Docket Items # 8 & 9
BAR CASE # 2015-00036 &
2015-00037

BAR Meeting
March 18, 2015

ISSUE: Permit to Demolish and Alterations

LOCATION: 535 North Columbus Street

Figure 1: View of previous first floor
open/covered rear porch

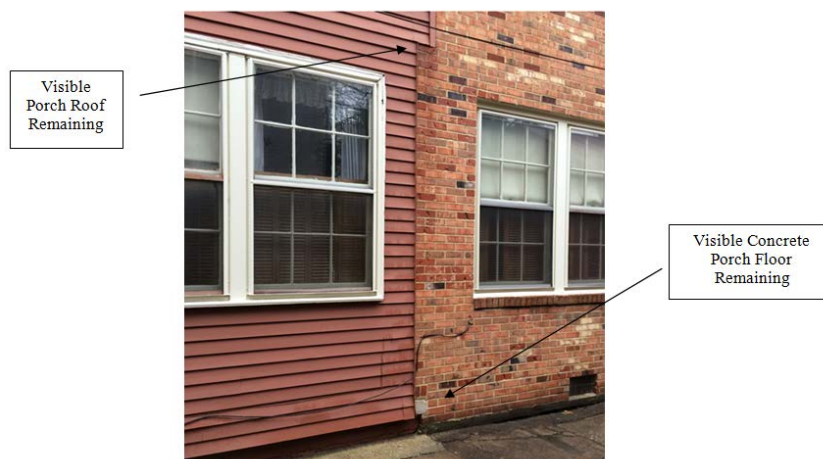
This two-story, three-bay, late-Victorian frame dwelling first appears on the **1912** Sanborn Fire Insurance map. The building is currently clad in metal siding over original wood siding. The roofline is detailed with a bracketed and denticulated cornice and a gabled louvered vent. It is capped with a small mansard roof which faces North Columbus Street and a low slope shed roof which slopes toward the east (rear) yard. The shed roof is detailed with two, corbelled brick chimneys. The south (side) elevation is punctuated with several 1/1 windows on the first and second floors, a full light door and two, 6/6 windows in the last two bays of the first floor – which likely enclosed an original open-covered porch (see photo below).

1 WEST DEMOLITION ELEVATION
A1 SCALE: 1/4" = 1'-0"

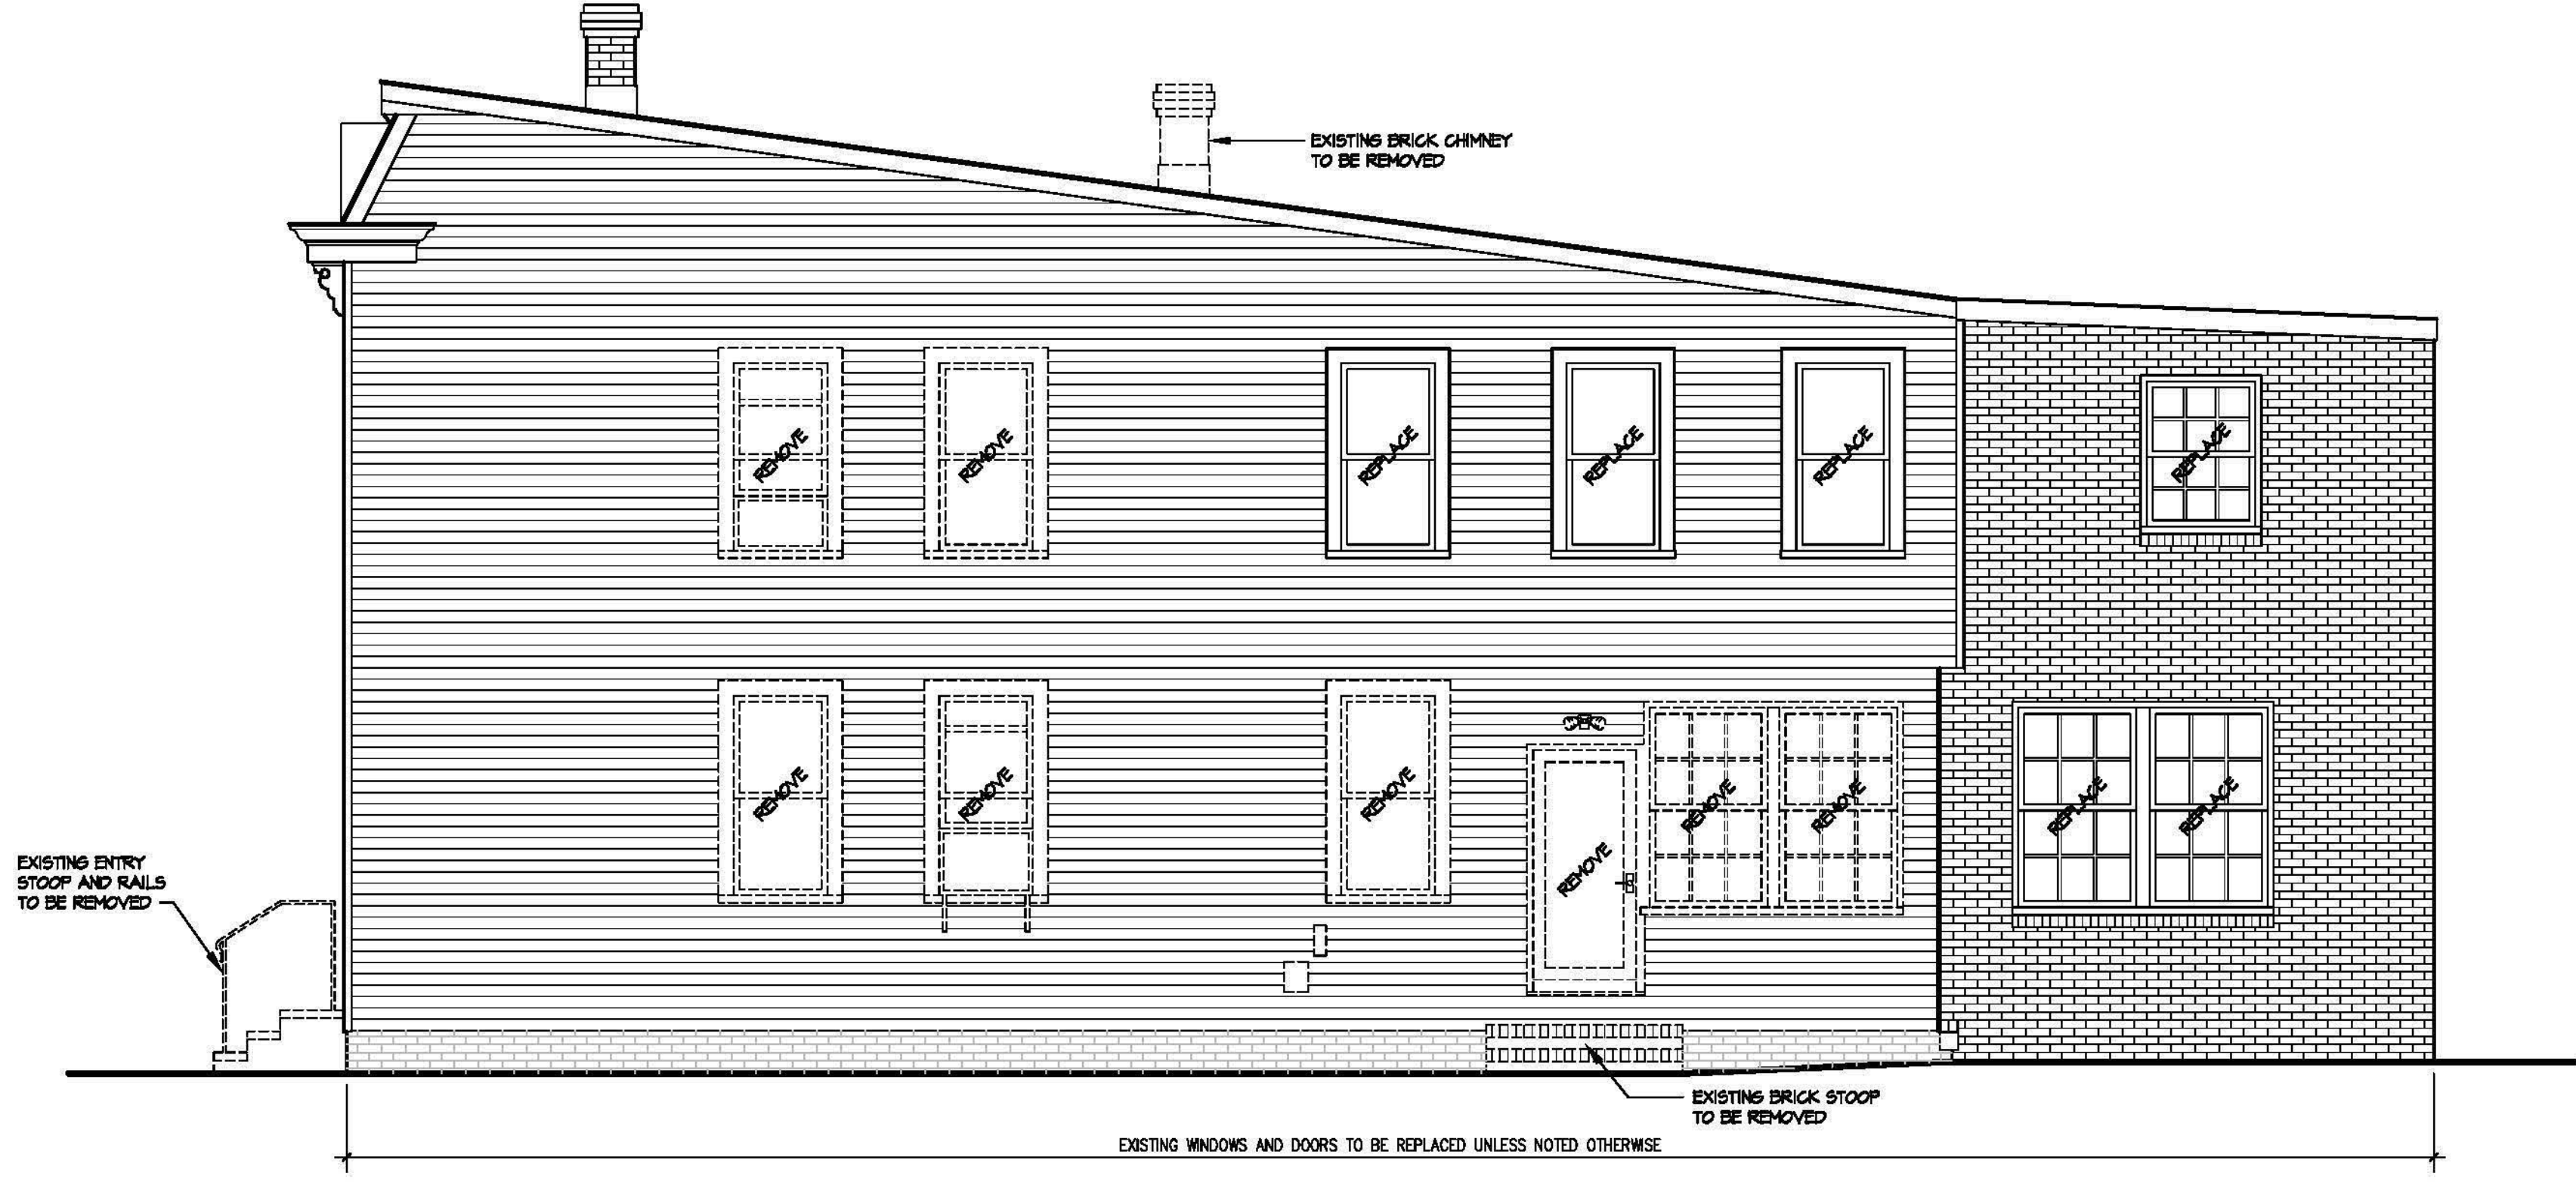
generally have ordinary or common features or elements. In this case, the applicant is proposing to remove five (5) original windows, the original front entry surround and transom, the historic wood siding on the side elevations and one original chimney in order to renovate and reconfigure the exterior and interior living spaces to accommodate the construction of a new house on the adjacent lot. Staff supports the removal of the windows on the south elevation for the construction of the adjacent house, as this infill is consistent with the historic development pattern within the district. However, staff opposes removal of the chimney, the entry surround and transom and the wood siding on the side elevations, as this amount of demolition will compromise the building's historic integrity and is at odds with the Boards adopted policies and *Design Guidelines*. In addition, staff finds that removal of these exterior features is not necessary to achieve the applicant's design goals.

Regarding the removal of the front entry surround and transom, the transom contains cylinder glass and the original surround appears to remain intact behind a simple 1 x 4 flat casing, likely added to pad the original trim when the aluminum siding was installed. The new slab door can be installed within this existing frame. Staff believes that the original front entry frame and transom should remain intact and be restored and not replaced.

Additionally, the proposal to replace the historic wood siding on the side elevations is premature, as the siding has not yet been removed and the condition of the historic wood siding underneath has yet to be assessed. However, even if the wood siding is in poor condition and cannot be

repaired or reused, staff does not support the replacement of the wood siding on the side elevations of this early 20th century intact resource with a modern material such as wood composite/synthetic lap siding. The Board's *Composite Siding Policy* approves the use of this modern material only on buildings and additions constructed after 1975. Therefore, staff recommends that the early wood siding be preserved and restored. However, if determined by staff that the wood siding is not salvageable, the siding may be replaced in-kind. Staff notes that *Parker Gray Guidelines* now permit the use of fiber cement siding on non-street-facing facades of all dwellings, where it is normally not easily seen or touched by the public. Street facing facades of early, pre 1932, structures must be original materials.

4. The existing original front entry frame, including transom will be retained and repaired. The existing face trim and door slab may be replaced, as proposed.

2 SOUTH DEMOLITION ELEVATION
A1 SCALE: 1/4" = 1'-0"

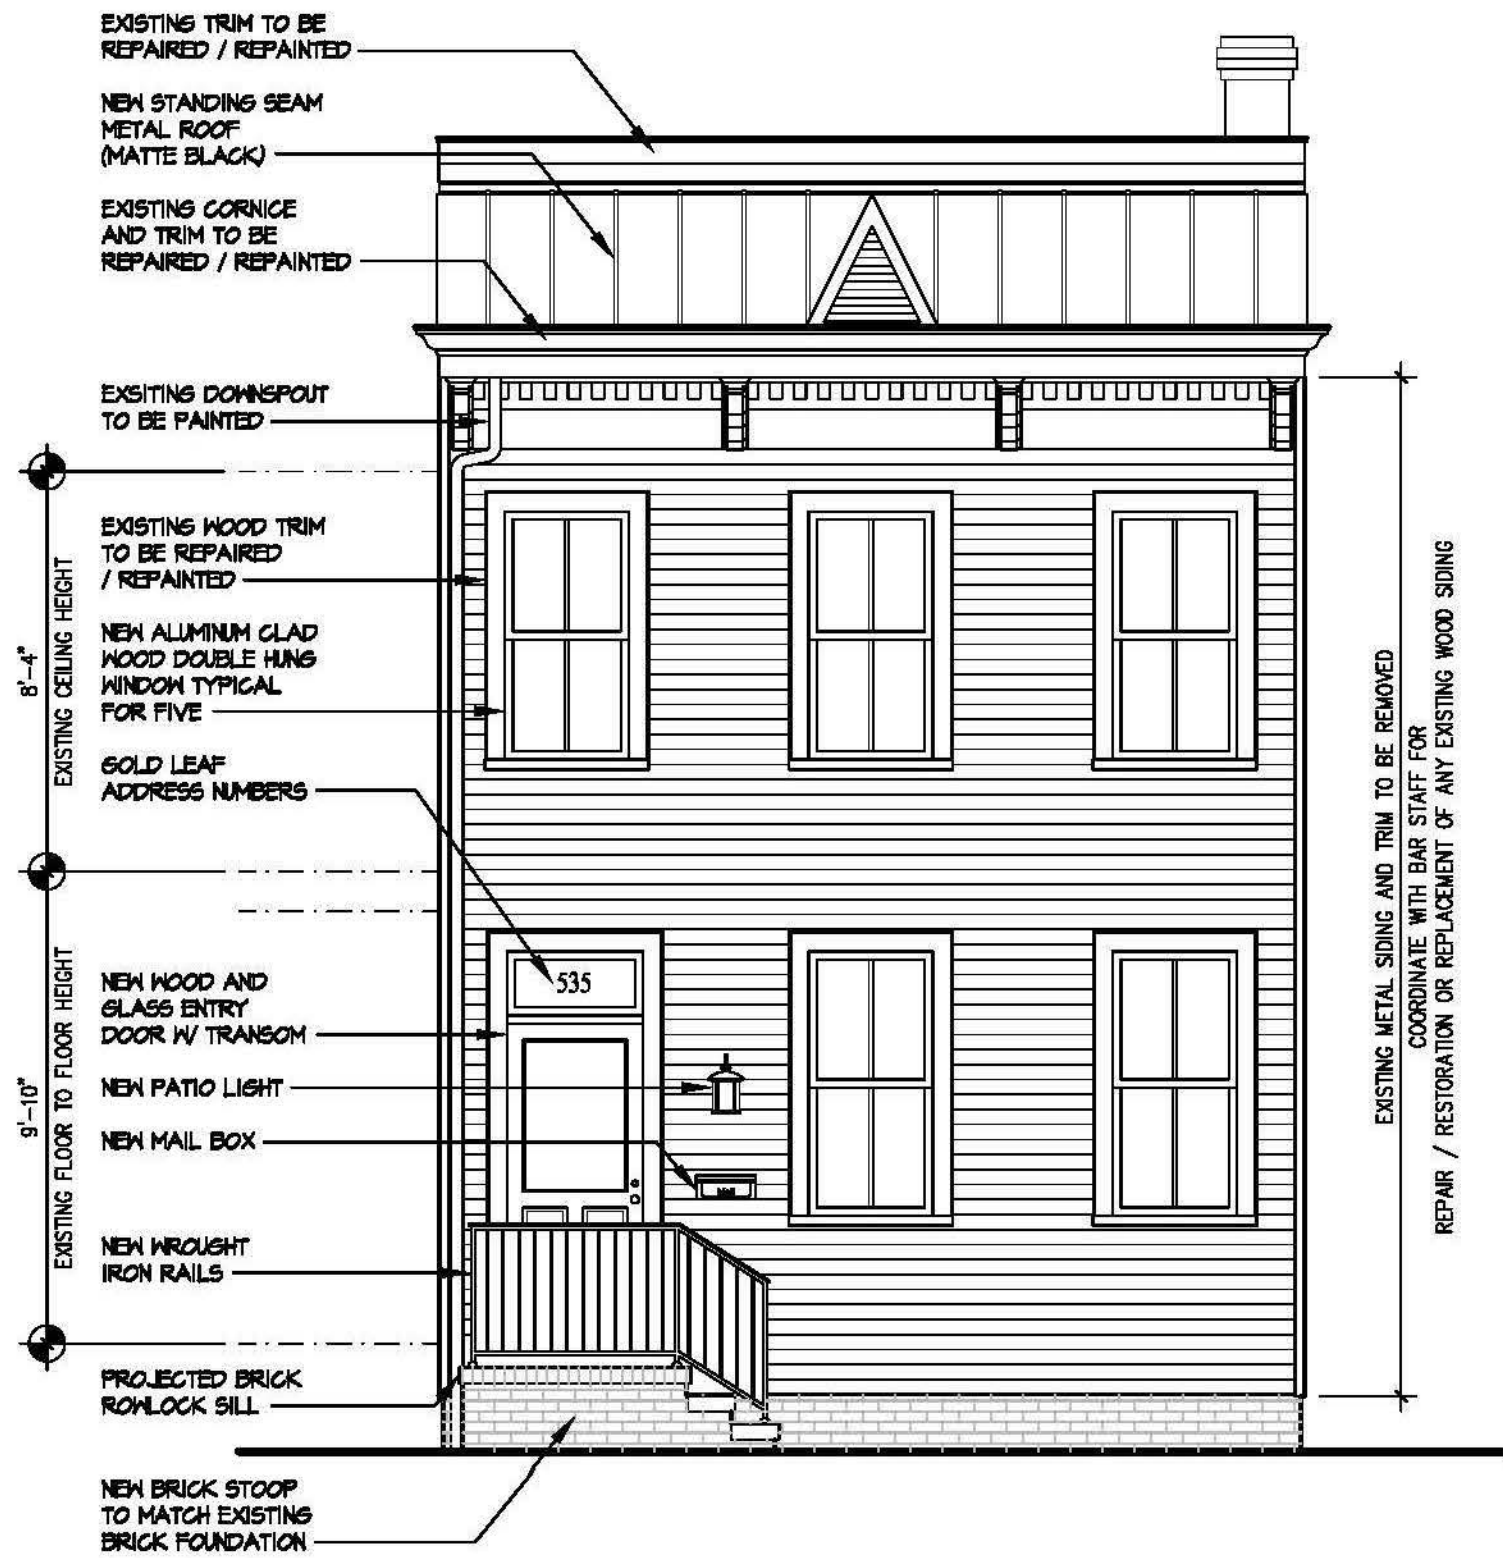
- Remove one of the two, existing corbelled brick central chimneys;
- Remove seven (7) windows¹ and one (1) door from the south (side) elevation. Frame in openings where the new house at 533 North Columbus Street abuts the existing building;
- Remove non-historic front entry's door slab, original frame and transom. Replace with a new, half-light wood entry door assembly with single-light transom;
- Demolish 133 sq. ft. of the brick addition's rear elevation to install a gang of three single light doors with transoms on the first floor and three, 2/2 windows on the second floor;
- Remove the existing metal siding to expose the historic wood German siding; Repair and replace on front elevation only.
- Remove metal and historic wood siding from north and south (side) elevations and install composite lap siding with a 5" exposure;
- Remove the existing brick stoop on the side elevation.

Finally, during staff's site visit to the property, the original masonry chimneys appear to be from the first period date of construction and utilize a traditional corbelled form. The *Design Guidelines* state that "chimneys can have an important impact on the overall visual composition of a building" and encourage their "maintenance in situ" and discourage their removal without a "compelling reason and substantial justification." For these reasons staff strongly supports the retention of the portion of both chimneys above the roofline as character-defining features of the original building mass, though staff notes that the chimney proposed for demolition is in the center of the structure and will not be easily visible once the abutting new house is constructed.

1. The historic central brick chimneys are not removed above the roofline.
2. Upon removal of the metal siding, staff will evaluate the condition of siding for repair or replacement per the BAR's siding policy. If the siding cannot reasonably be retained, new wood siding must be used on the side elevations per the Board's policy.
